**ALTERNATE SHUTDOWN FUSE TRANSFER RELAYS
 SCHEME 1KM106**

ALTERNATE SHUTDOWN CAPABILITY SYSTEM

| 7884 | BECH-E112 <32> | 0 | 0 |

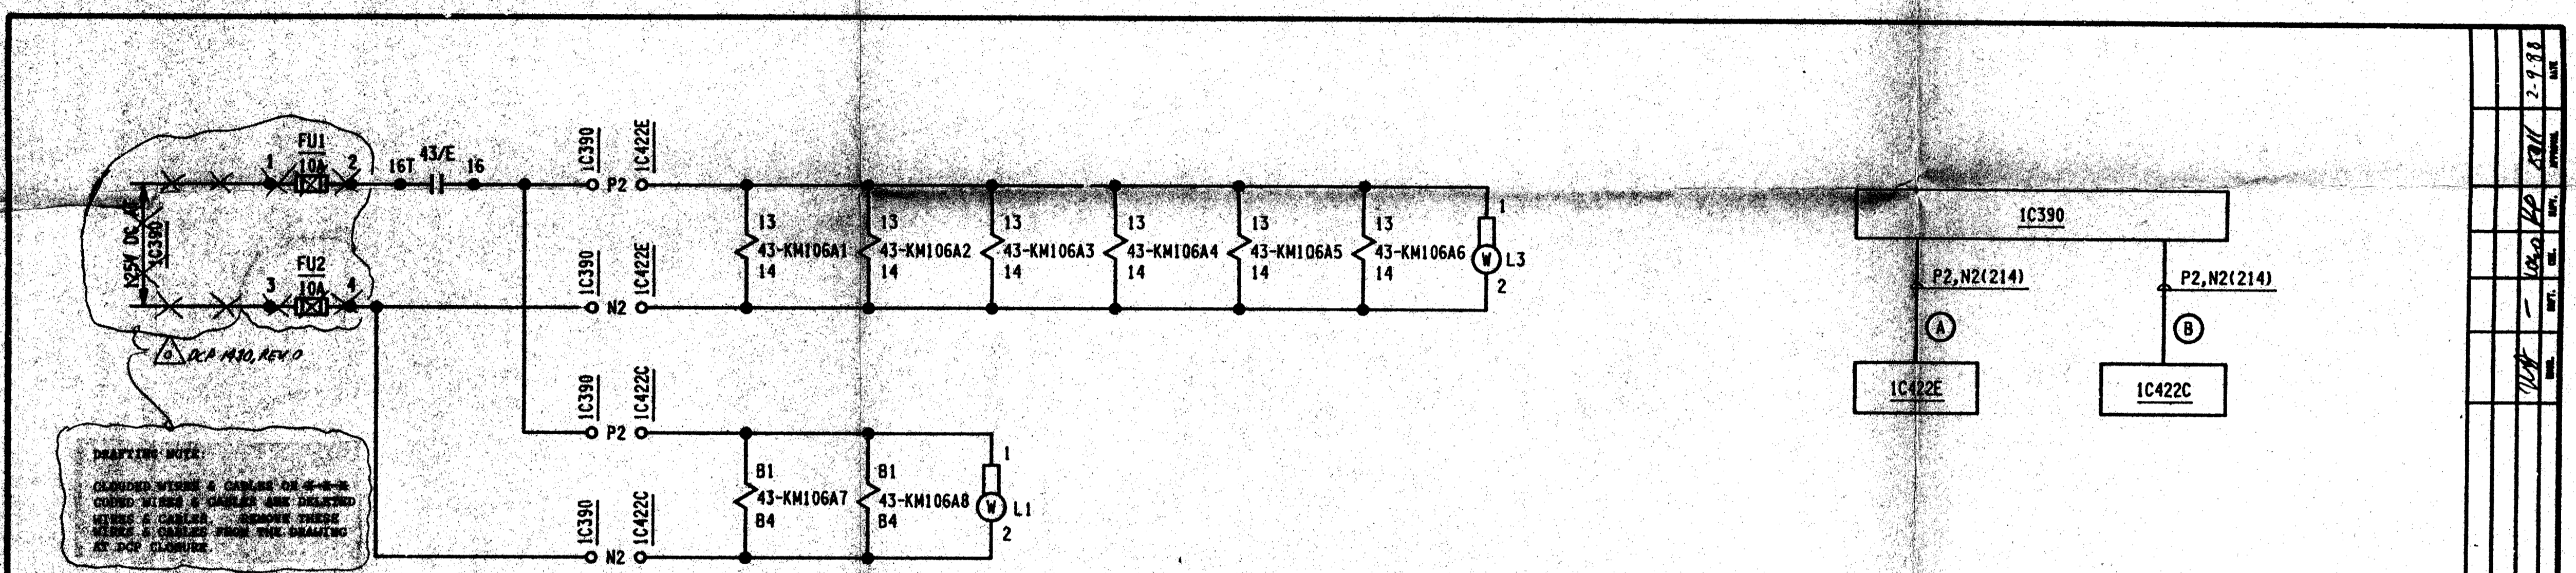
DRAFTING NOTE
 CHANGED WIRE & CABLE ON 6-2-82
 CONDUIT WIRE & CABLE ARE DESIGNATED
 WITH A CIRCLE. REMOVE THESE
 WIRE & CABLE FROM THE DRAWING
 AS PER CHANGE.
